UNITED STATES PATENT AND TRADEMARK OFFICE

APPLICATION NO.	FILING DATE	FIRST NAMED INVENTOR	ATTORNEY DOCKET NO.	CONFIRMATION NO.
10/789,597	02/27/2004	Kirt Martin	STE01 P-1158	9061

Office Action Summary	Application No. 10/789,597	Applicant(s) MARTIN ET AL.	
	Examiner Noah C. Hawk	Art Unit 3636

DETAILED ACTION

Bayles, Figure 2

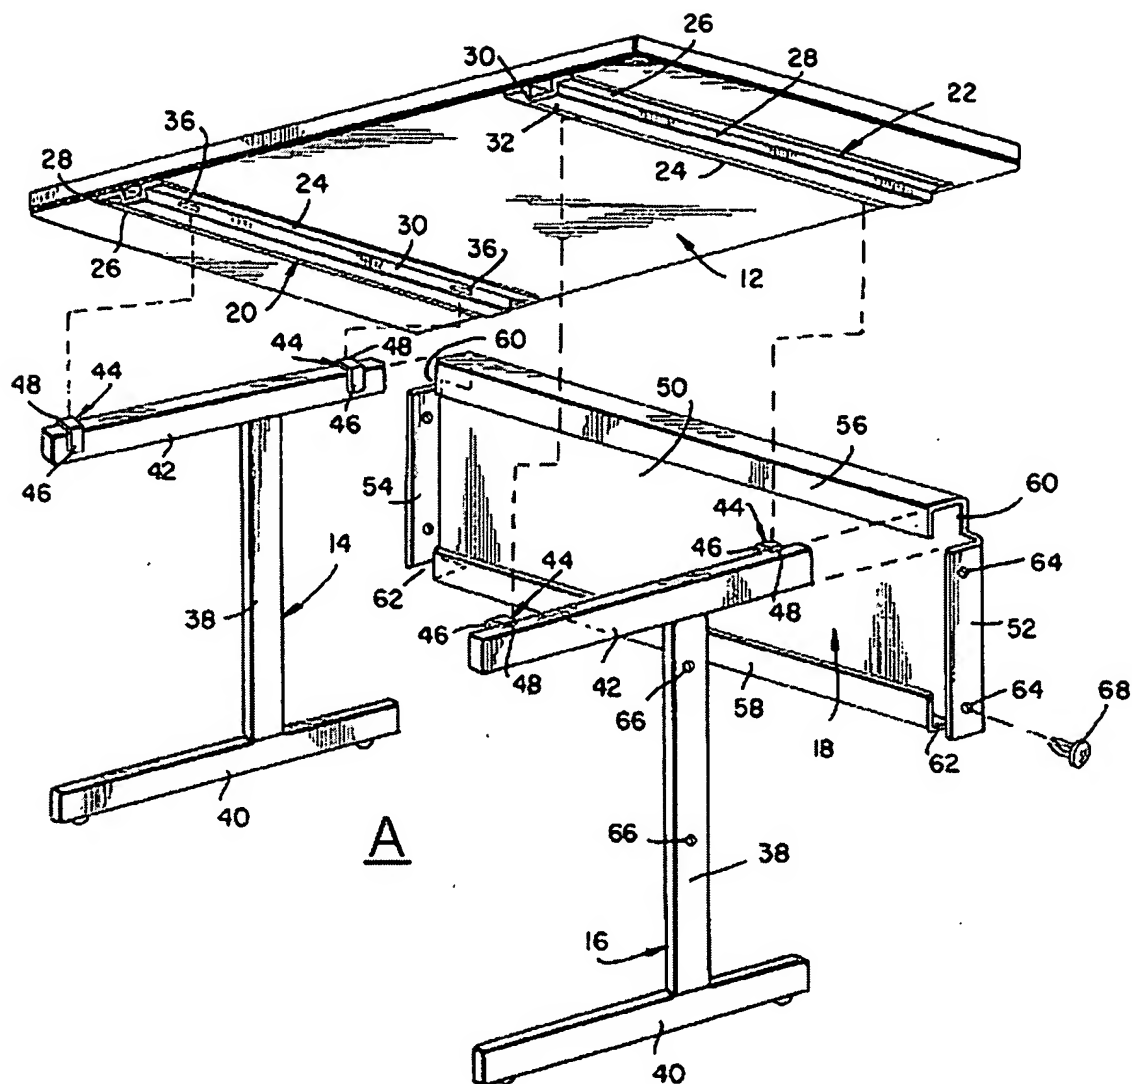
a. Regarding Claim 1, Bayles teaches a privacy screen (18) for use within a desk assembly having a worksurface (12) and an open span (A, best seen in Bayles, Figure 2) located below the worksurface comprising a first member (18) having a generally planar first portion (best seen in Bayles, Figure 2), a first flange (58) extending longitudinally along the first planar portion, and a first end (52) and a second end (54) adapted to be secured to a desk assembly within an open span (A) located below a worksurface (12) of the desk assembly. Bayles fails to teach a telescoping privacy screen. Long teaches a device including a telescoping privacy screen (22 and 22a) for use in different sized desks. It would have been obvious to one of ordinary skill in the art at the time of invention to modify the device of Bayles by using a telescoping privacy screen as taught by Long in order to "fit different desk dimensions" (see Long, Column 1, lines 9-10). Bayles, as modified, does not teach details of the telescopically adjusting second portion of the privacy screen. Diamond et al. teach a panel having two members (20, 22), the first member (20) having a generally planar first portion (best seen in Diamond et al., Figure 1), a first flange (32) extending longitudinally along the first planar portion and a second member (22) having a generally planar second portion (best seen in Diamond et al., Figure 1), a second flange (36) extending longitudinally along the second planar portion and configured to telescopically

receive the first flange of the first member therein such that planar second portion is substantially proximate the planar first portion thereby allowing adjustment of an overall length of the panel extending between the first end and the second end. It would have been obvious to one of ordinary skill in the art at the time of invention to modify the device of Bayles, as modified, by using a telescopically adjusting panel as taught by Diamond et al. in order to allow the user to mount the panel on a diverse selection of desks with different span sizes.

- b. Regarding Claim 2, Bayles, as modified, further teaches that the first flange (58) is substantially C-shaped (best seen in Bayles, Figure 2).
- c. Regarding Claim 3, Bayles, as modified, fails to teach details of the second flange. Diamond et al. further teach that the second flange (36) includes

Diamond, et al., Figure 2

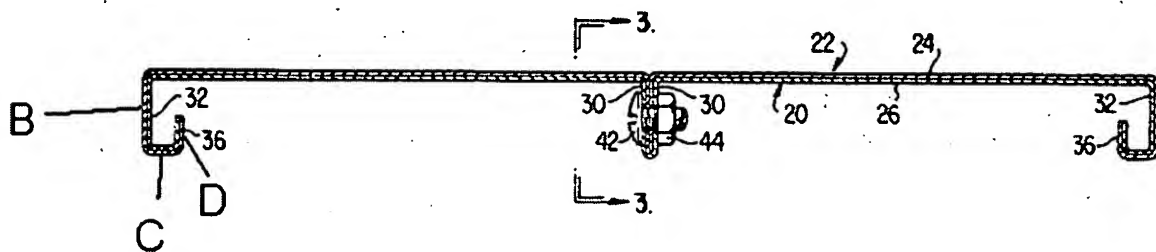
a first portion (B) extending from and substantially orthogonal to the second planar portion, a second portion (C) extending from and substantially orthogonal to the first portion, and a lip portion (D) extending from the second portion and towards the second planar portion. It would have been obvious to one of ordinary skill in the art at the time of invention to modify the device of Bayles by using a flange with three portions as taught by Diamond et al. in order to allow the panel to be folded into shape.

d. Regarding Claim 4, Diamond et al. further teach that the second flange (36) is substantially C-shaped (best seen in Diamond et al., Figure 2). It would have been obvious to one of ordinary skill in the art at the time of invention to modify the device of Bayles, as modified, by using a C-shaped second flange as

Diamond et al., Figure 2 (Detail)

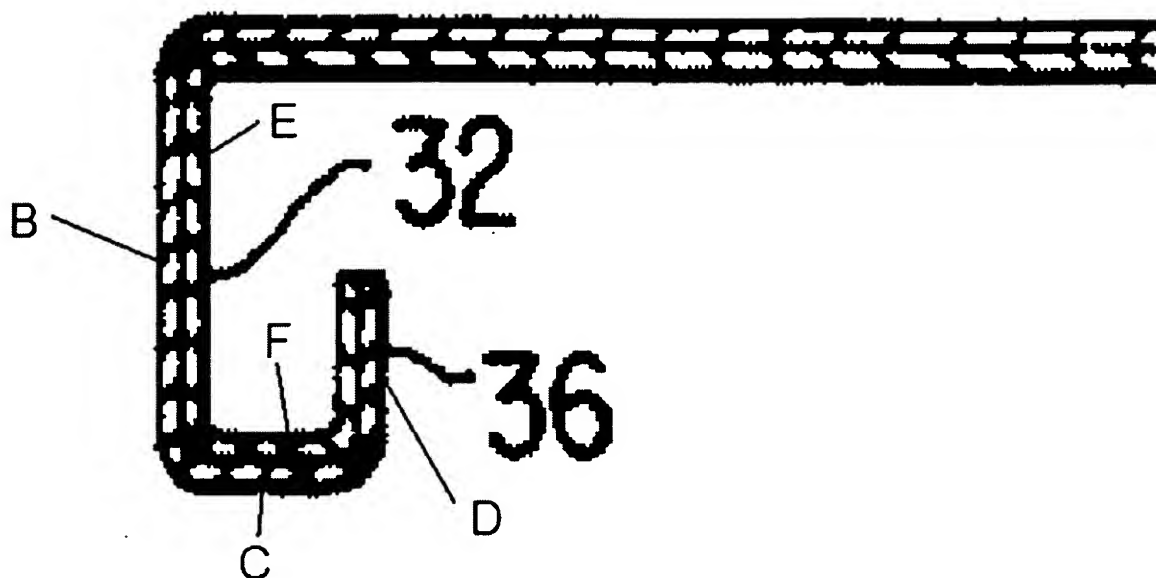
e. Regarding Claim 5, Diamond et al. further teach that the *first* flange (32) includes a first portion (E, best seen in Diamond et al., Figure 2 Detail, below) extending from and substantially orthogonal to the second planar portion and a second portion (F) extending from and substantially orthogonal to the second portion of the *first* flange, and wherein the second portion (F) of the *first* flange is telescopingly received between the second portion (C) of the *second* flange and the lip portion (D) of the *second* flange (Note: the second portion of the *first* flange is considered received by the *second* flange as it resides in the space defined by the second portion and the lip portion). It would have been obvious to one of ordinary skill in the art at the time of invention to modify the device of Bayles, as modified, by using a two-portion *first* flange as taught by Diamond et al. in order to allow the panel to be folded into shape. (Emphasis added)

p. Regarding Claim 16, Diamond et al. further teach that the *first* flange (32) of the *first* member (20) includes a first portion (E, best seen in Diamond et al., Figure 2 Detail, above) extending from and substantially orthogonal to the second planar portion and a second portion (F) extending from and substantially orthogonal to the second portion of the second flange, and wherein the second portion (F) of the *first* flange is telescopingly received between the second portion (C) of the *second* flange and the lip portion (D) of the *second* flange (Note: the second portion of the *first* flange is considered received by the *second* flange as it resides in the space defined by the second portion and the lip portion). It would have been obvious to one of ordinary skill in the art at the time of invention to modify the device of Bayles, as modified, by using a two-portion *first* flange as taught by Diamond et al. in order to allow the panel to be folded into shape. (Emphasis added)
